**APPLICATION FOR PERMISSION
UNDER SECTION 16 OF
THE TOWN PLANNING ORDINANCE
(CAP. 131)**

For Official Use Only 請勿填寫此欄	Application No. 申請編號	A/SLC/189
	Date Received 收到日期	6 FEB 2025

(b) Intended use/development 有意進行的用途/發展	<p>Proposed Public Utility Installation (LV Cable Laying, Overhead Line Pole and Overhead Line Pole Stay) and Excavation of Land and Filling of Land</p> <p>擬議的公用事業設施裝置 (低壓電纜安裝接駁, 低壓架空天線棟及土爹安裝)及填土及挖土工程</p>
--	--

TITLE :POLO & STAY ERECTION &
LV CABLE LAYING AT
PUI O BEACH, PUI O

Tree Survey Report for Pole and Stay Erection and LV Cable Laying at Pui O Beach, Pui O Appendix A Tree Location Plan

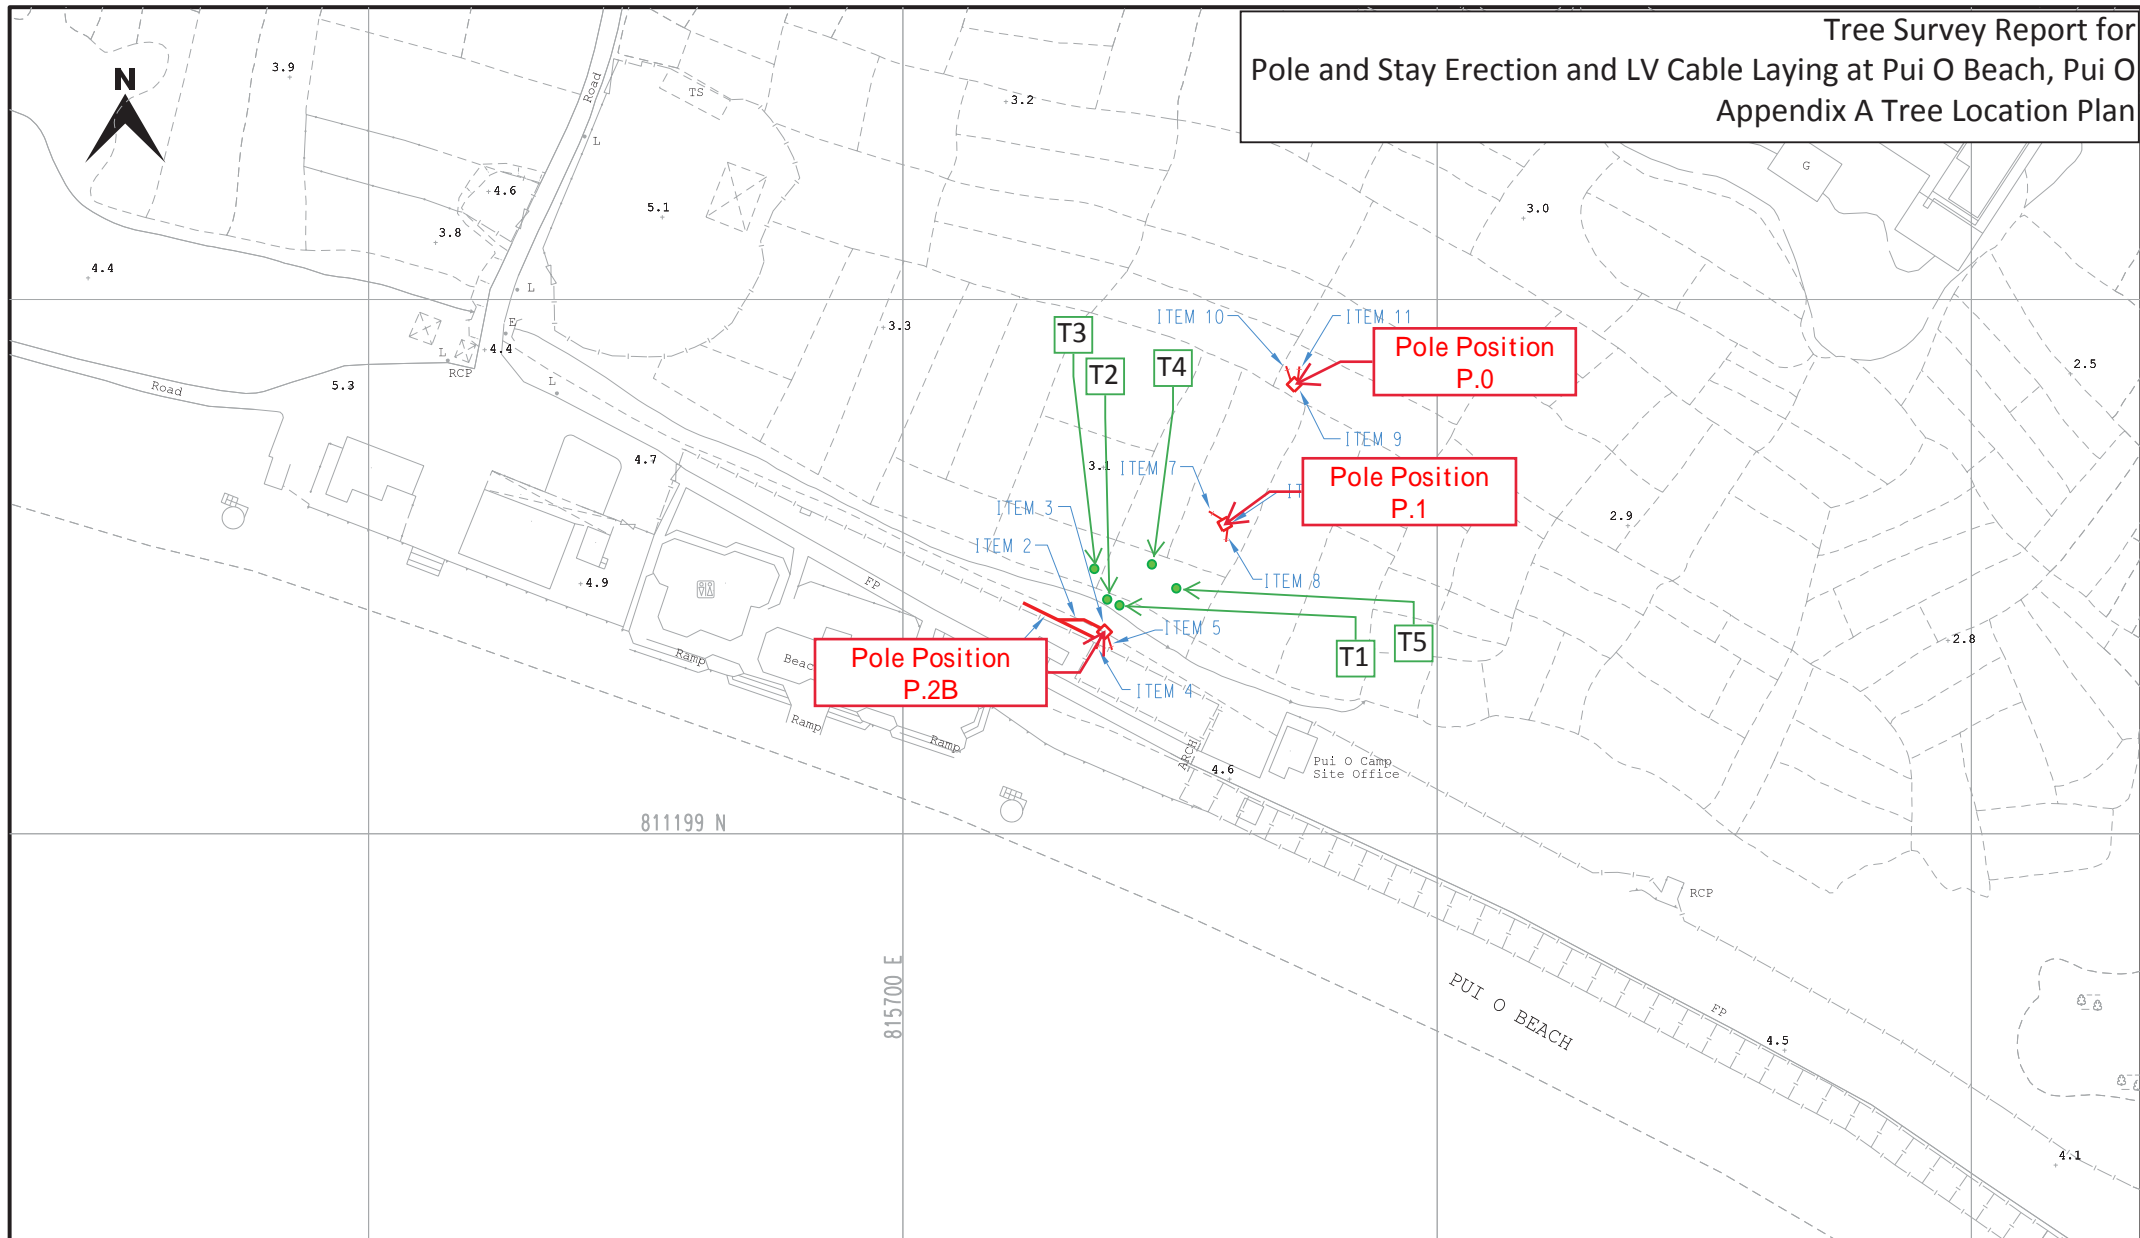
Based on the tree survey on 29th February 2024, there were 5 trees of common species recorded in the vicinity. One dead tree, T4, was recorded.

It is confirmed that no Trees of Particular Interest (TPI) was recorded in this survey.

All surveyed trees will be retained on-site.

From: Lam, Siu Cheong
Sent: Tuesday, February 11, 2025 11:15 AM
To: 'Dates Yat Ching YEUNG/PLAND' <dycyeung@pland.gov.hk>
Subject: FW: Clarification of Request of Comments on Cable Trench Work at Pui O Beach, Pui O (WELT2023-0189-02)

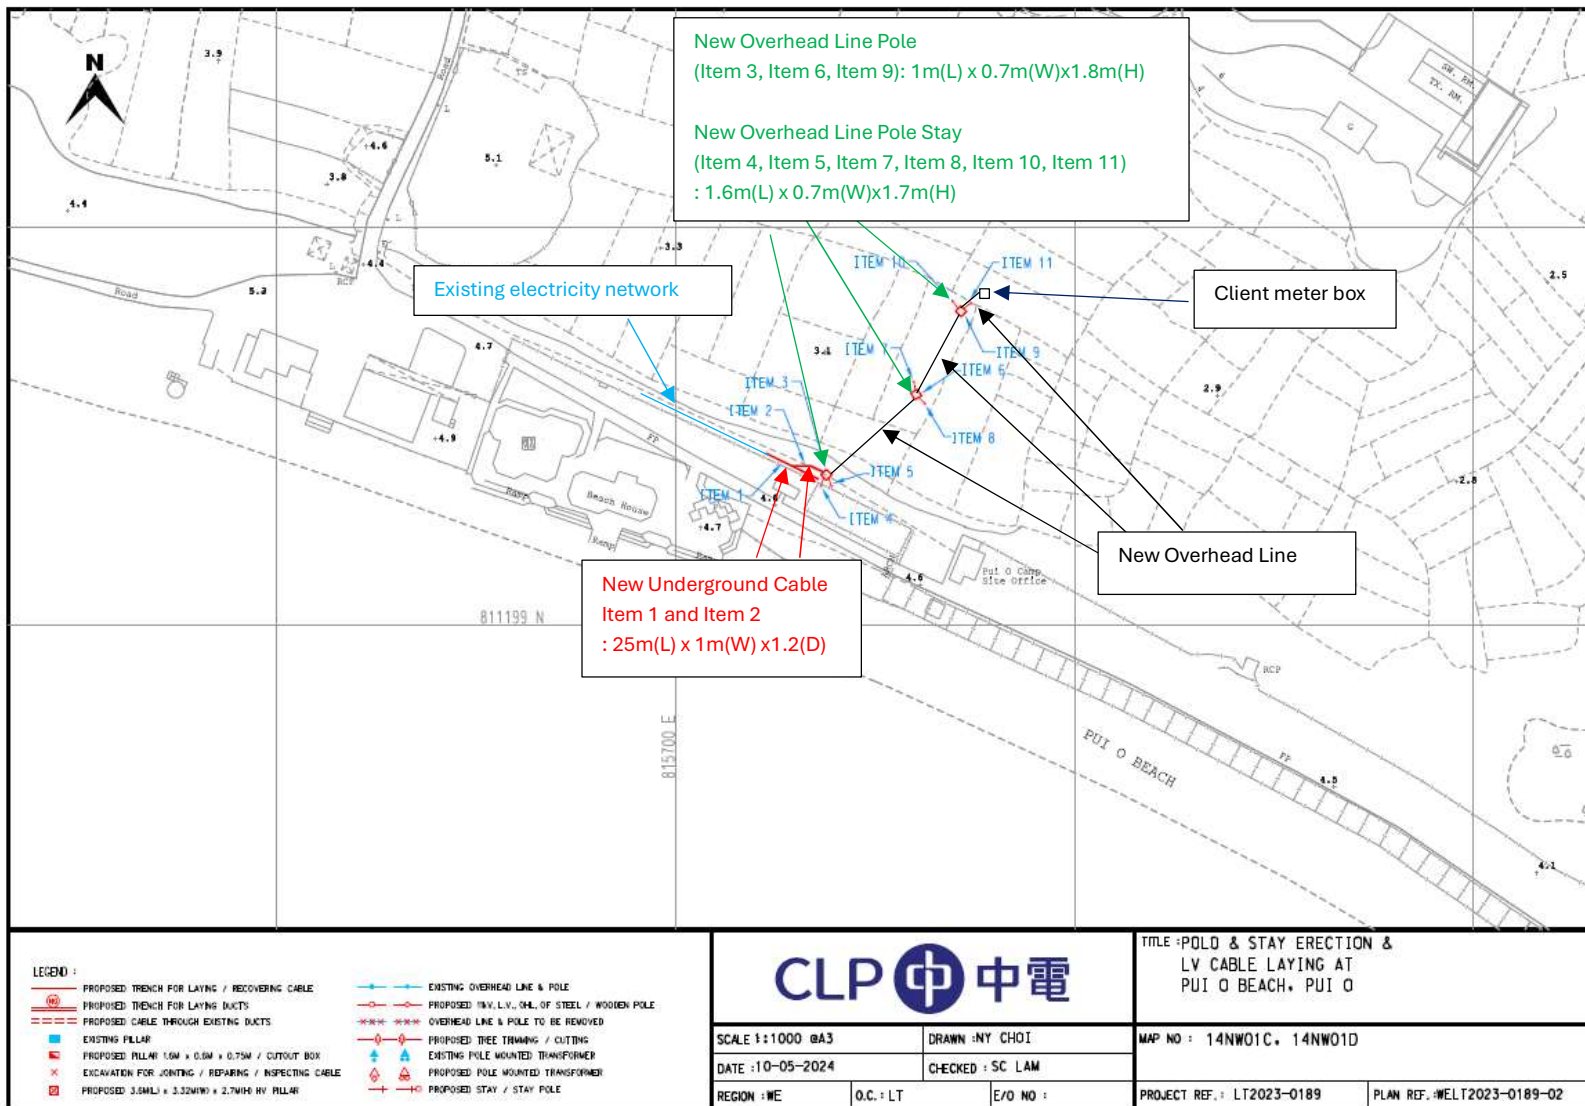
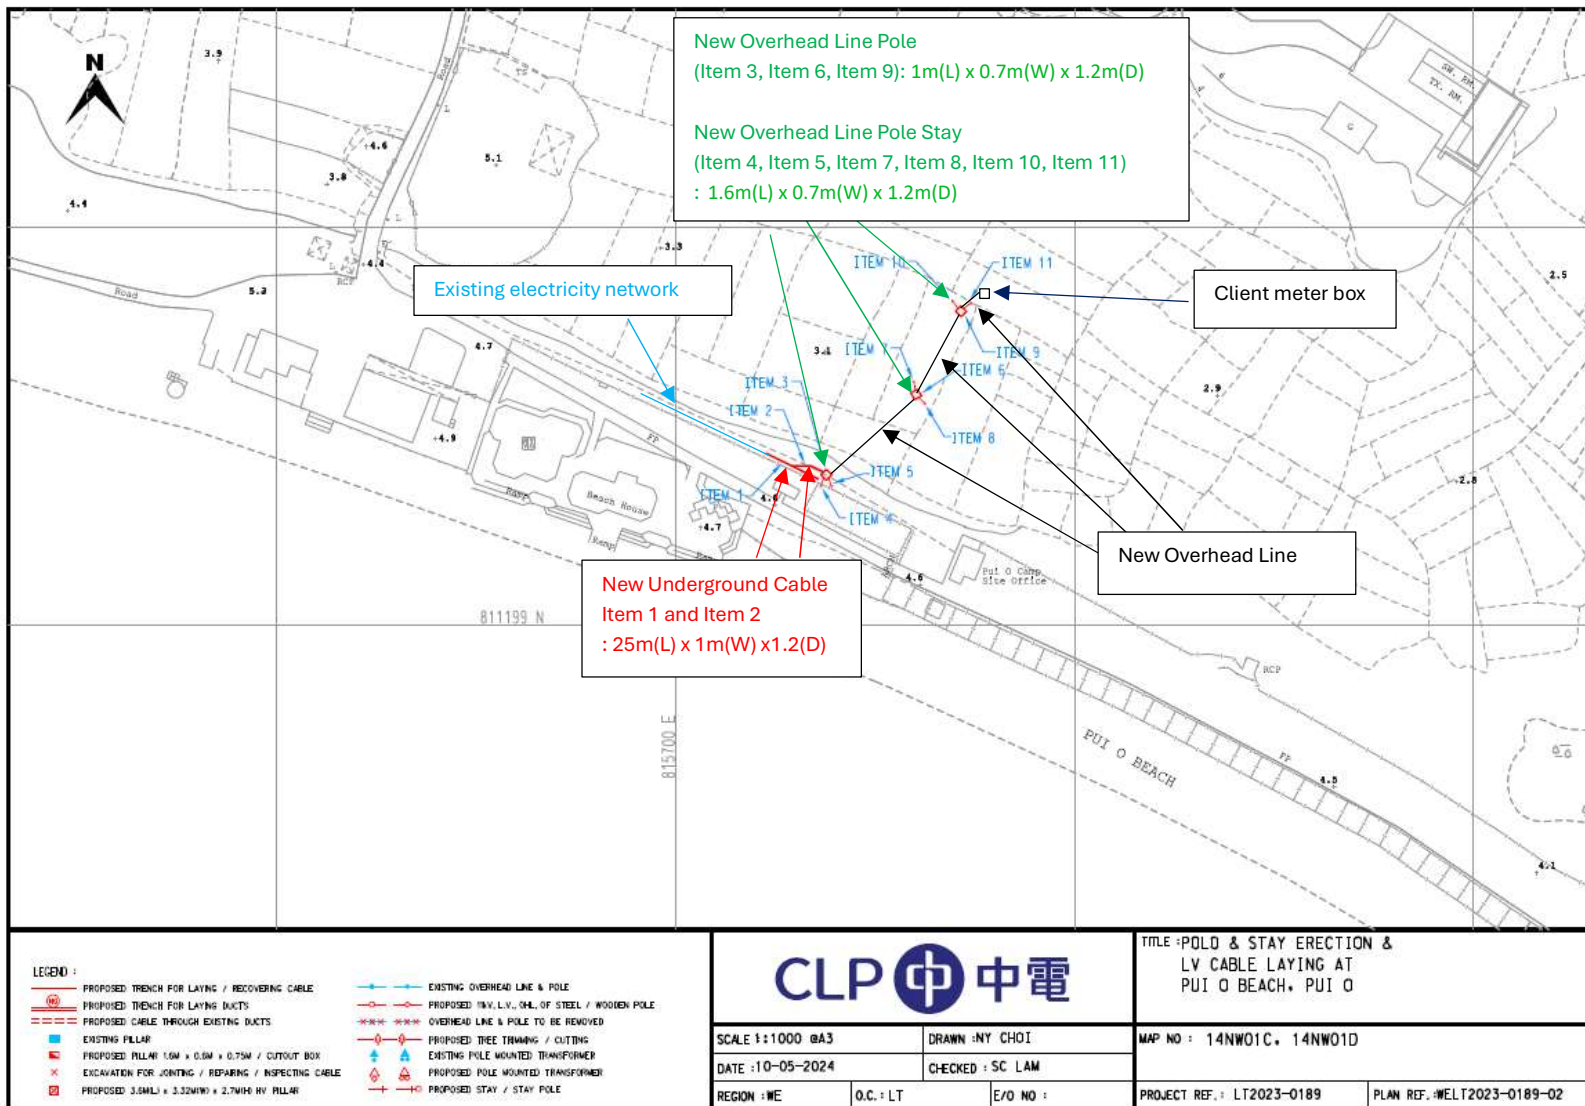
4. Please find the updated replacement page and Summary drawing for your reference. whilst the proposed heights of the proposed poles and stays are 9.3m and 3m respectively

New Overhead Line Pole
(Item 3, Item 6, Item 9): 1m(L) x 0.7m(W) x 1.2m(D)

New Overhead Line Pole Stay
(Item 4, Item 5, Item 7, Item 8, Item 10, Item 11)
: 1.6m(L) x 0.7m(W) x 1.2m(D)
